Caltrans Responses to ECRB Questions Part 2 – August 29, 2025

PIPE PIN ASSEMBLY DETAILS

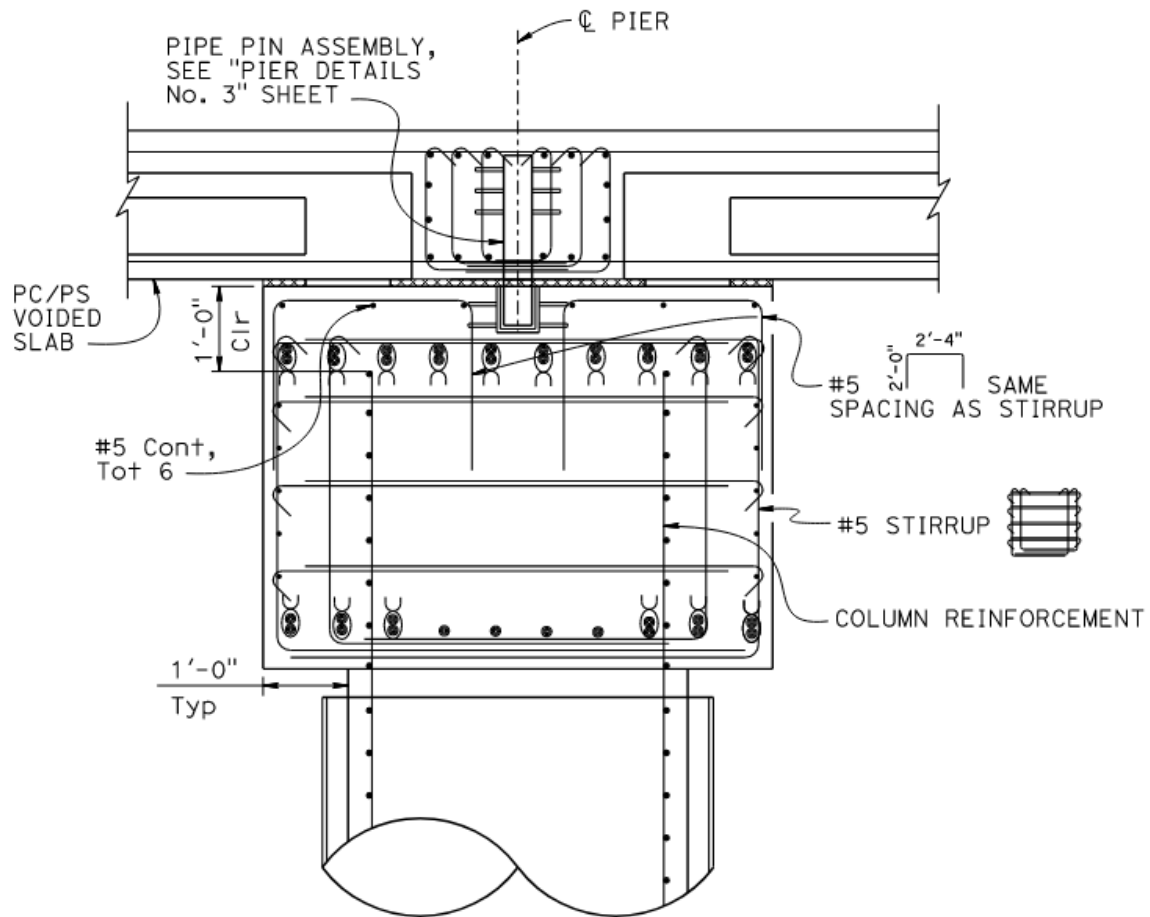
2. Do we understand correctly that the positive attachment of the bridge deck to the abutments and pile caps consists entirely of the pin connections, which are sacrificial elements that will break under seismic loads that are less than the design level loads. After the pin connections break the bridge deck would be free to slide around on top of the pile caps for the duration of the earthquake and during aftershocks.

- a. If this is not correct, please describe what the positive attachment is that prevents the deck from sliding off the abutments and pile caps after the pin connections break.

- b. If this is correct, then the design would seem to rely on the pile caps being wide enough that there is plenty of room for the pier deck to slide around in all directions without losing bearing capacity from the supports below. This would be an unusual seismic design strategy for most structures and, if it is the intended approach here, there should be a well-established criteria for determining the sliding displacement that must be accommodated in all directions, and possibly other requirements as well. We have reviewed the Caltrans Seismic Design Criteria 2.0 document and we are unable to find any mention of this as an acceptable seismic design strategy or any established criteria for deploying it. Please point out where in the Caltrans Seismic Design Criteria 2.0 document this strategy is discussed and where the appropriate criteria is defined. In the sketch provided with the draft responses to ECRB comments it appears that there is a total bearing width of 66 inches at the abutment in the longitudinal direction prior to any earthquake loading. Per the draft responses to ECRB comments, “ongoing seismic analysis shows longitudinal displacement demands are up to 52 in.” It remains unclear if the calculation of 52 inches recognizes that the fuses have broken at service level loads and the deck is sliding free for the duration of the earthquake, which could result in significantly larger displacements. It remains unclear if additional displacements due to torsional rotation of the deck, aftershocks, or other causes have been

adequately considered and whether the remaining 14 inches of bearing support, beyond the 52 inch displacement is adequate. If this is the intended strategy, please provide an established criteria that supports the approach of allowing the deck to slide freely without positive attachment anywhere, defines the appropriate criteria for managing sliding displacements, and demonstrate how that criteria will be met.

There is a secondary system in place to handle longitudinal movement as well as any movements beyond the fault rupture displacement. The detail below shows the pipe pin assembly which allows for engagement of the pier caps in the longitudinal direction under all loading cases (service, seismic etc.), in this direction the assembly acts as a typical pipe pin which has been utilized on many Caltrans projects. In the Transverse direction the fault rupture design displacement will be allowed to occur, the gap inside of the assembly was designed based on this displacement, any unanticipated displacement beyond the fault rupture will be restrained by this pinned connection. Additional seat width in the transverse direction has also been provided at the Pier Caps and Abutment to prevent unseating.
